PROCLAMATION CALLING A SPECIAL MEETING OF THE BERKELEY CITY COUNCIL

Thursday, July 23, 2020

SECTIONS

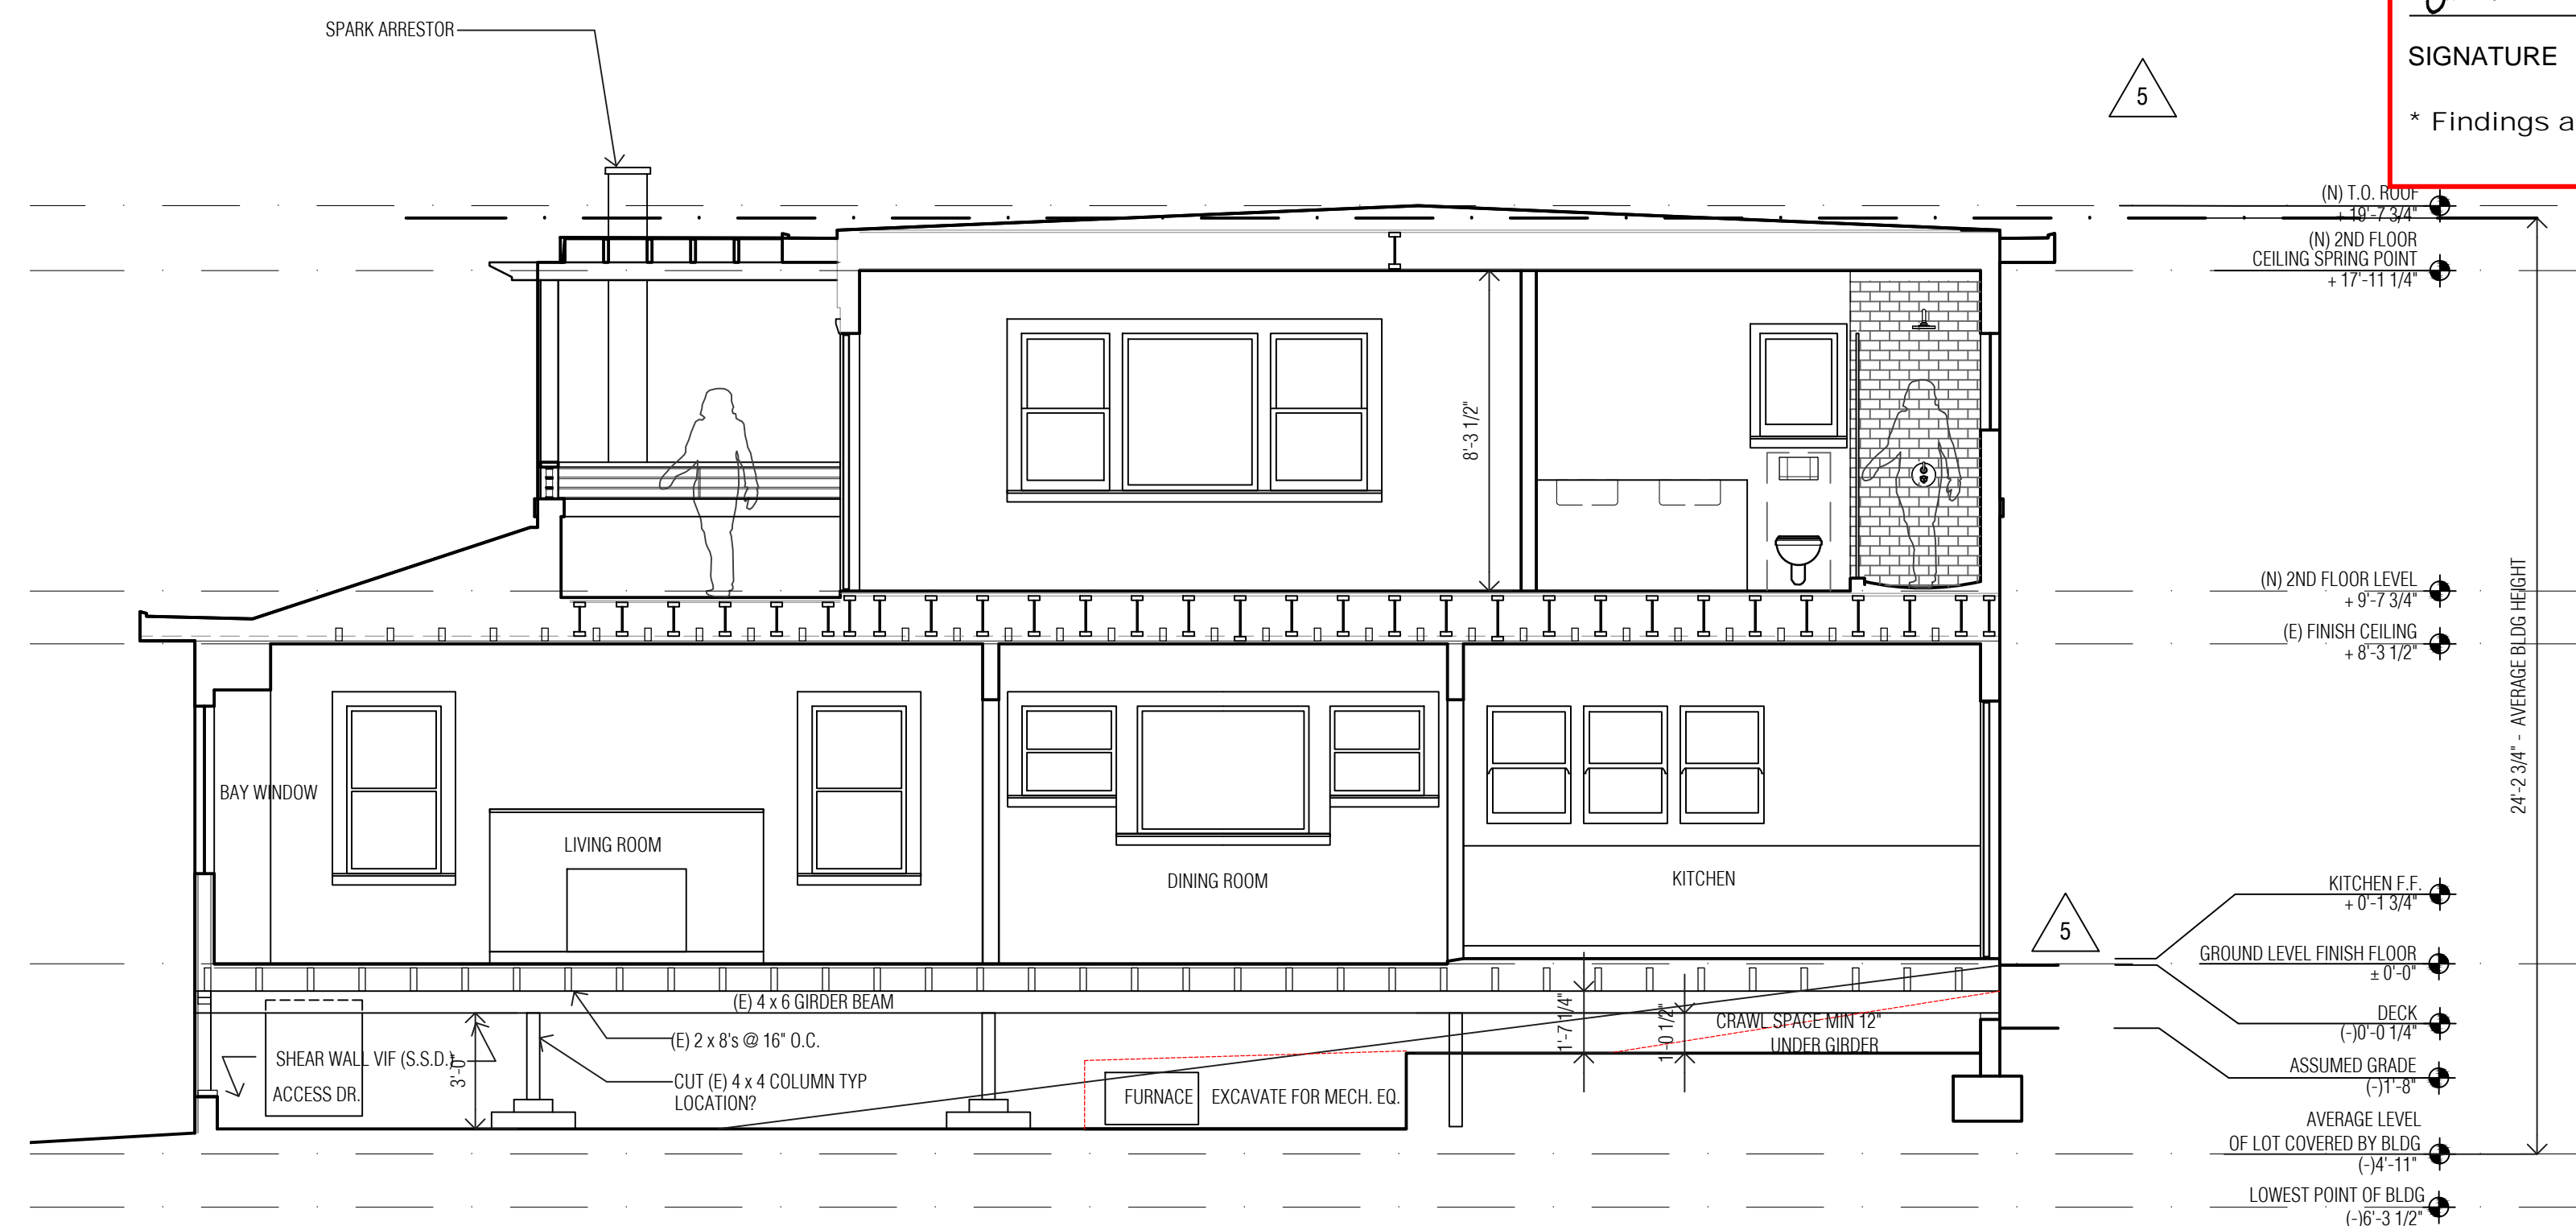
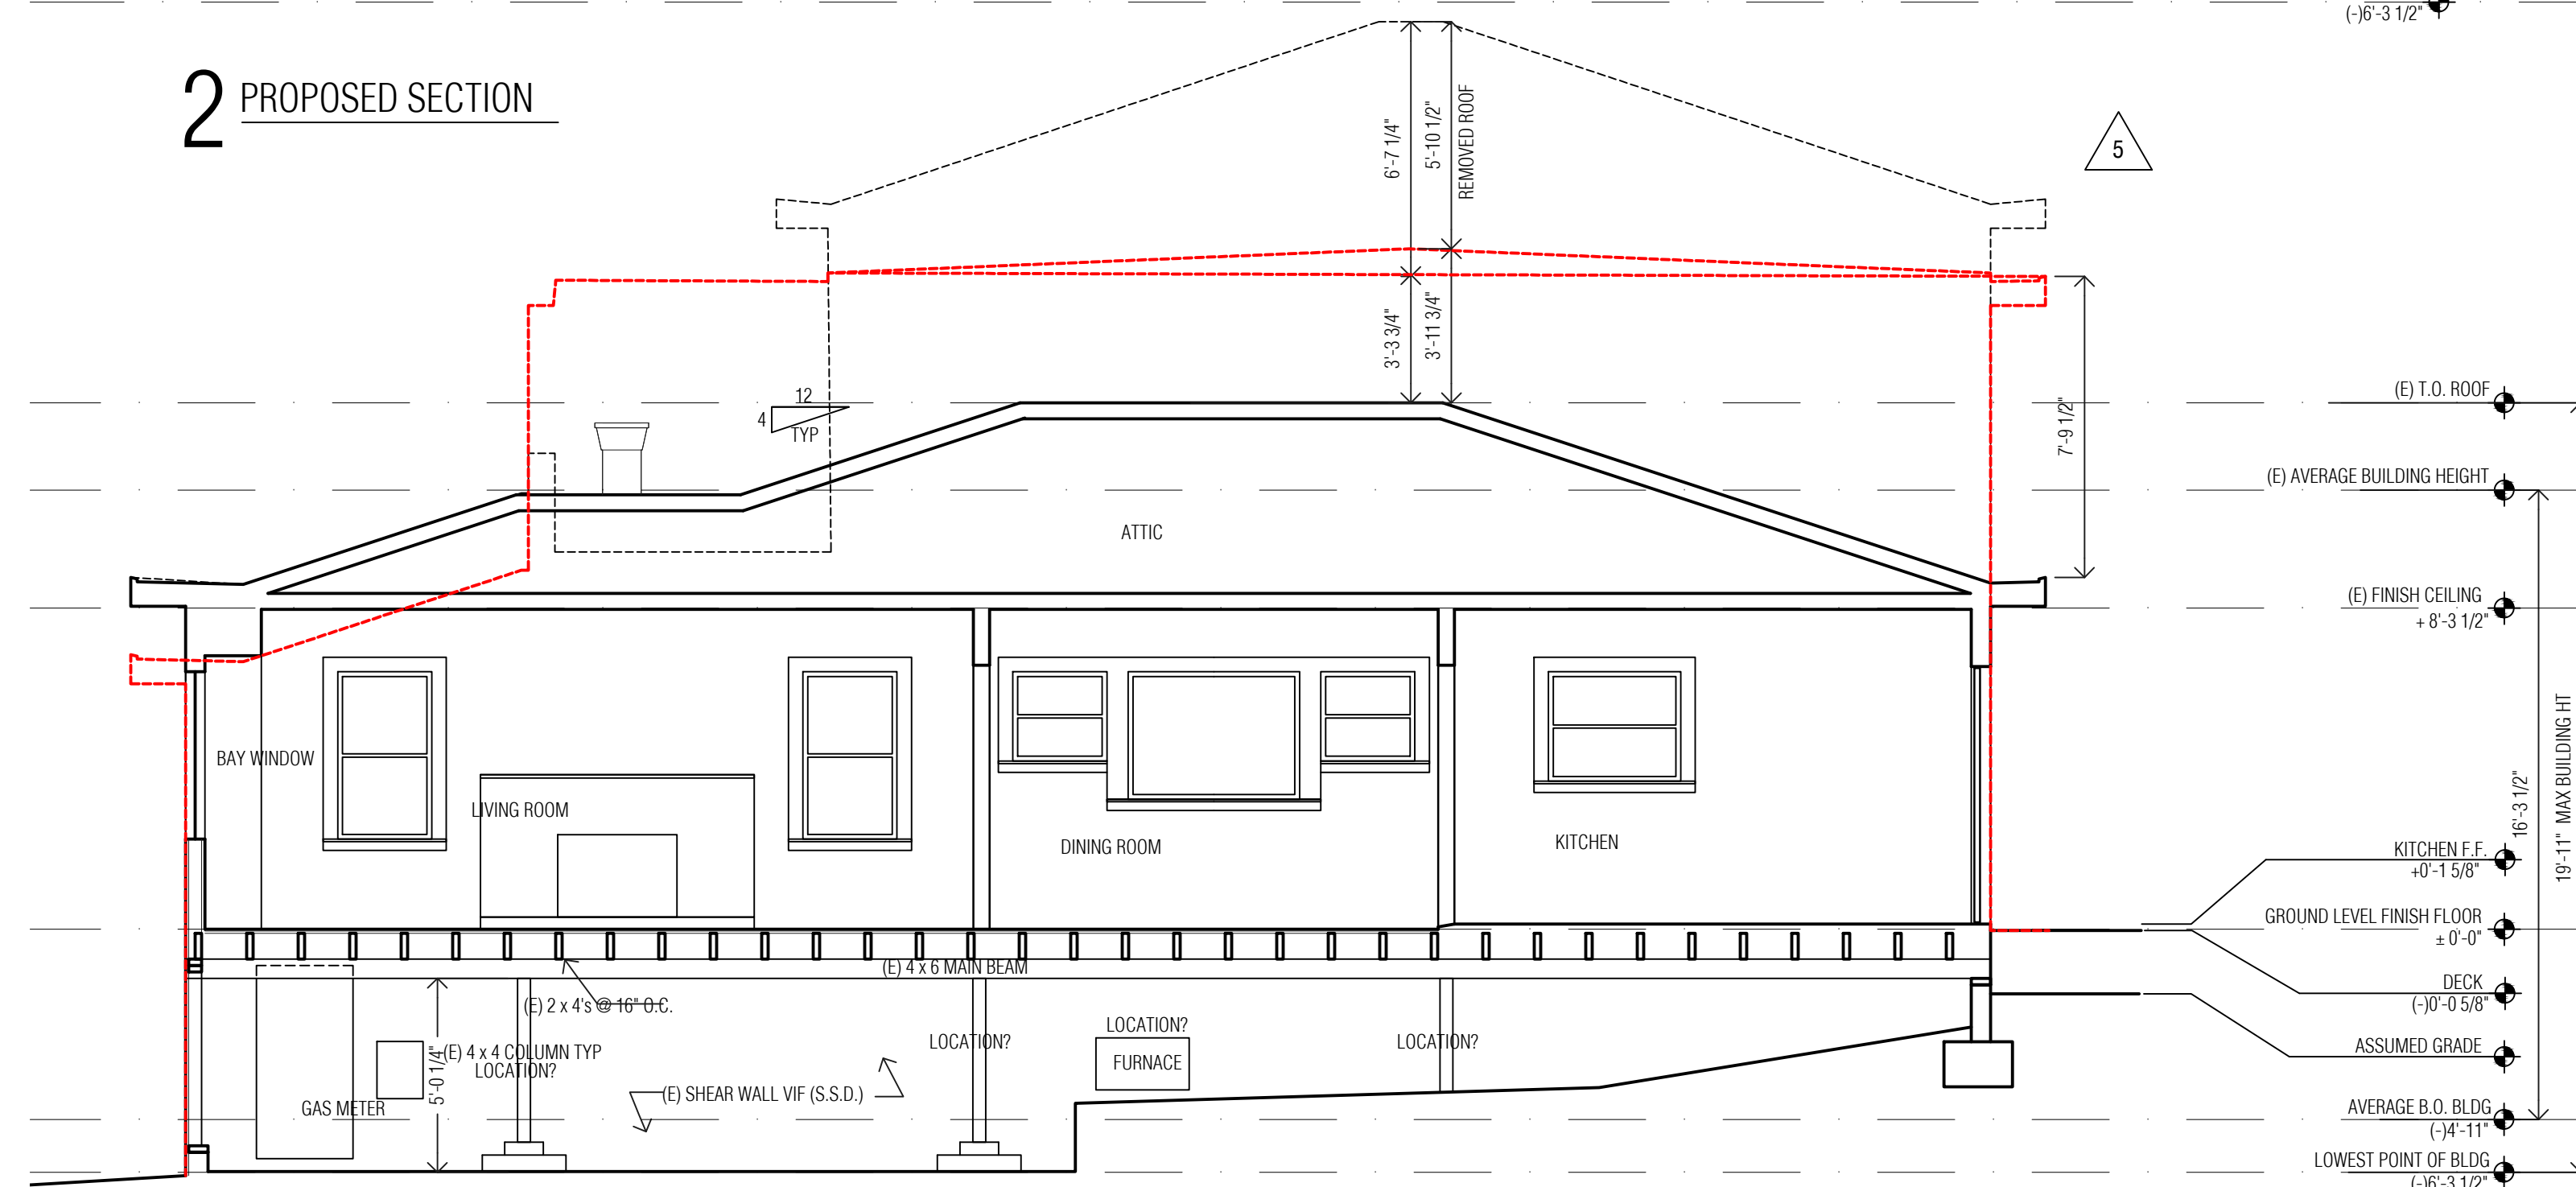
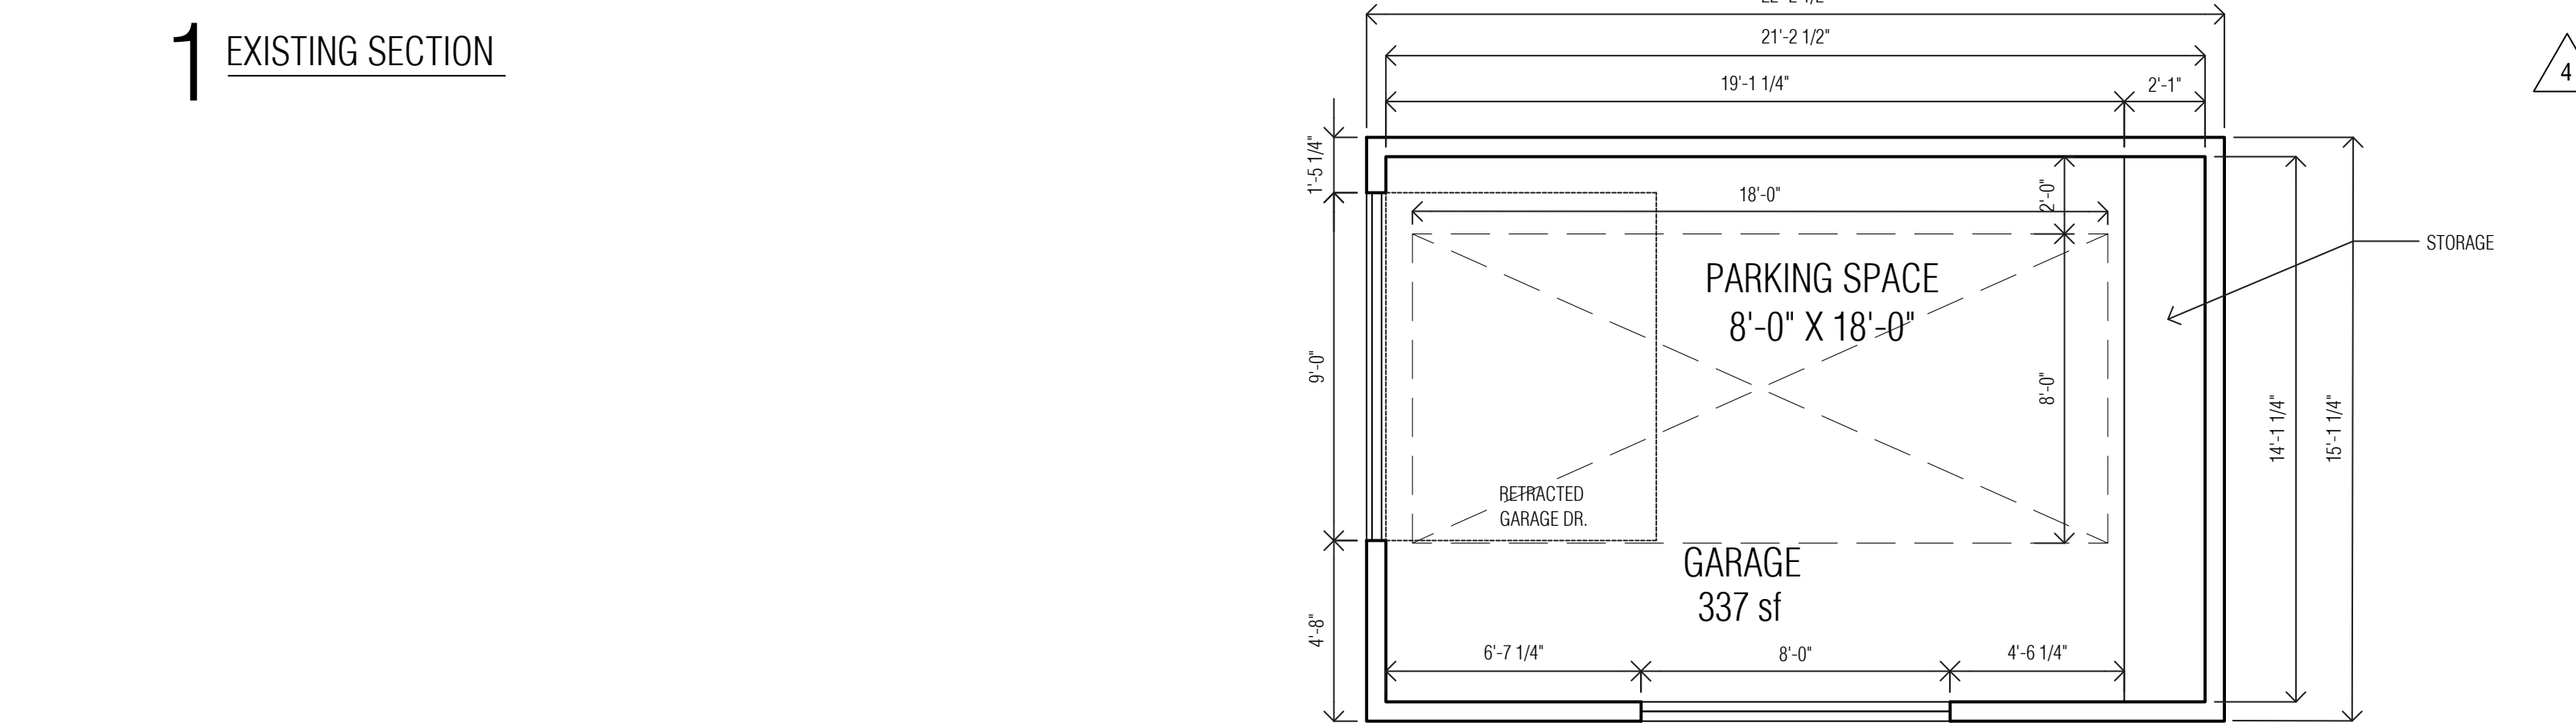
preserving the entire view, unless the building were lowered at least 18 inches. The applicant has already agreed to lower the ceiling height on the second floor, and is lowering the ground level finished floor such that the height of the crawl space below the house is reduced from 5 feet ¼ inch to 3 feet 6 ¾ inches (see the existing and proposed sections on sheet A3.2).

13. Finished Floor. The new finished floor shall be two feet lower than the existing surveyed finished floor, as measured from the front of the dwelling and shown in the sections on sheet A3.2 of the plans received by Land Use Planning on July 1, 2019. This condition shall be noted in the Building Permit plan set.

32. Maximum Height of the Top of the Roof. The top of the roof for the addition shall be no higher than 4 feet above the existing roof, as shown in the Existing Section on sheet A3.2, of the plans received by Land Use Planning on July 1, 2019. The elevation of the top of the new roof shall be verified by a licensed surveyor after framing is complete and before final inspection. A letter from the surveyor documenting the top of the roof elevation shall be provided to Land Use staff before final inspection.

Photo 1: Story Poles with Design Revision Indicated, As Seen from the Kitchen Table of 1710 Sonoma Avenue. Photo by Amy Di Costanzo.

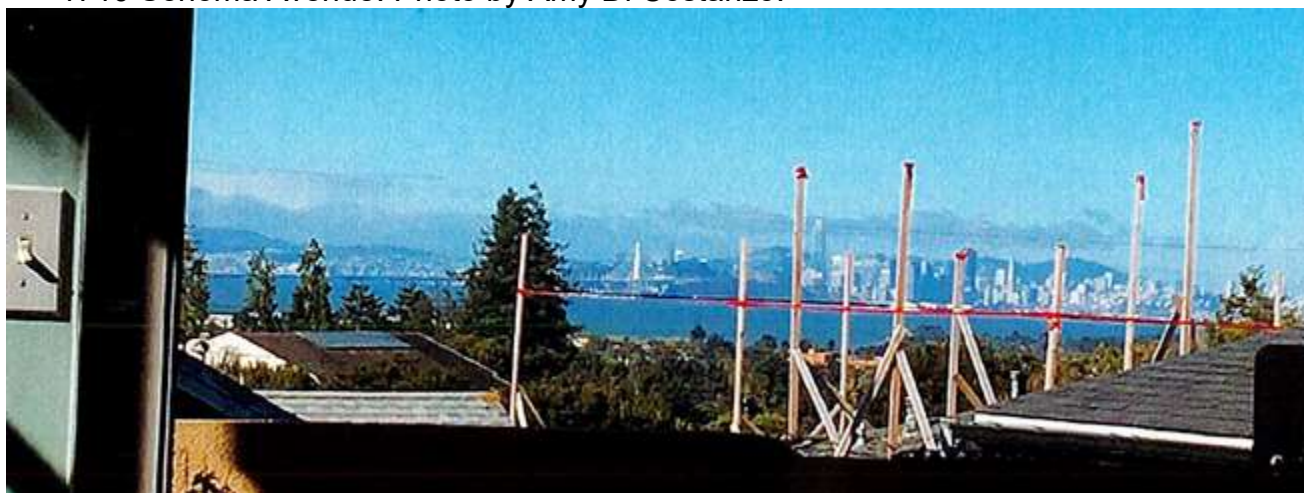
The appellant submitted photos of the view from their kitchen toward San Francisco in their appeal letter. Photo 1 below was taken from a seated position at the table at the back of the kitchen, with the doors to the deck open. The original story poles are in the photo, and the height of the proposed building after the plans were revised is indicated by the red horizontal line.

Staff Response: The BMC defines a view corridor as a “significant view of the Berkeley Hills, San Francisco Bay, Mt. Tamalpais, or a significant landmark such as the Campanile, Golden Gate Bridge, and Alcatraz Island or any other significant vista that substantially enhances the value and enjoyment of real property.” The photos submitted by the appellant show the story poles at the height of the original design for the addition, with a string at a lower height to reflect the revisions to the project. The string between the story poles indicates how the applicants lowered the proposed height and replaced the sloped roof with a flat roof. With the revised addition, the Bay Bridge and San Francisco Skyline would still be visible from the kitchen of 1710 Sonoma Avenue. Although the view of the water below the Bay Bridge and San Francisco Skyline would

2 OPTION 1 - PROPOSED 2ND FLOOR PLAN

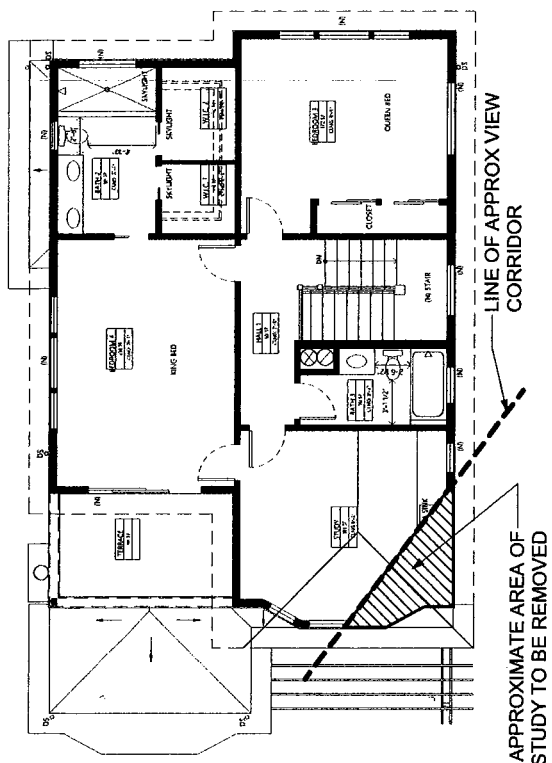
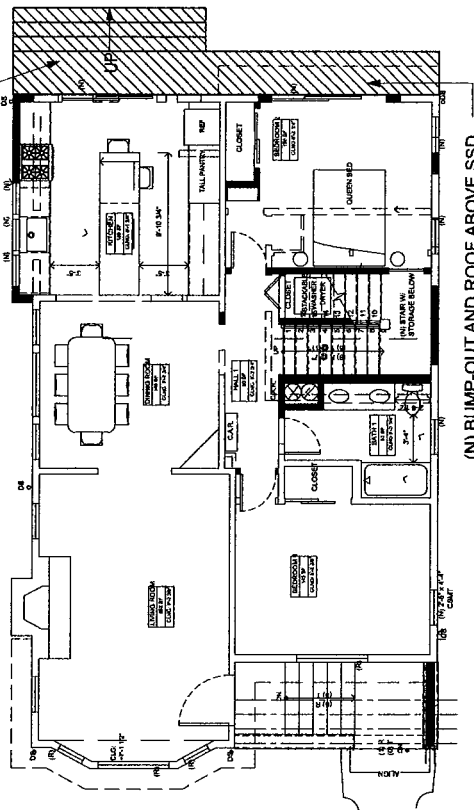
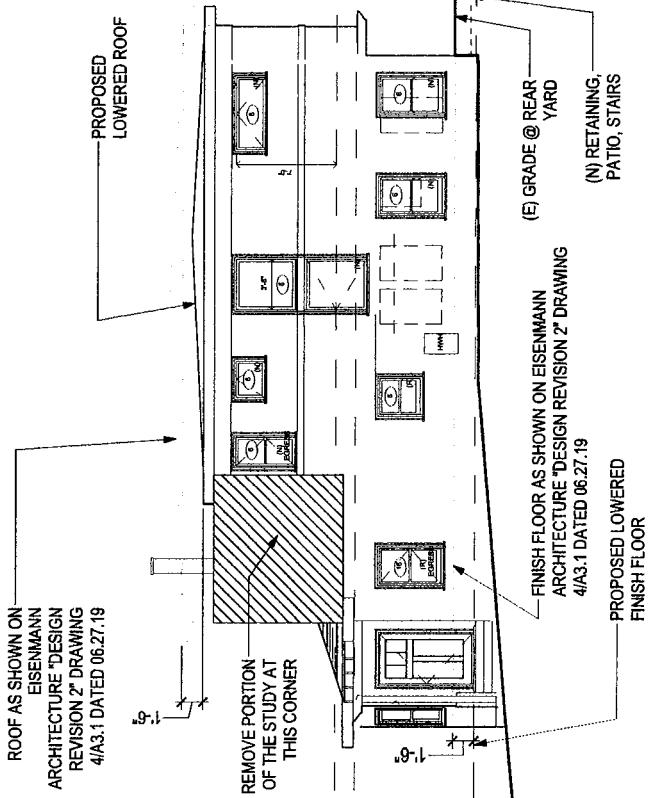
STACY PROPOSED THE FOLLOWING TO ALLOW SOME BREAK IN THE (AS NOW DESIGNED) TOTALLY BLOCKED VIEW CORRIDOR:

I really like Option 1 because it eliminates the "walled-in" aspect from many perspectives by providing an opening. The walled-in feeling would be most acute when in my garden. Eliminating the front corner would allow a partial view of San Francisco and the bay to remain (see photo from my garden at sunset – Option 1).
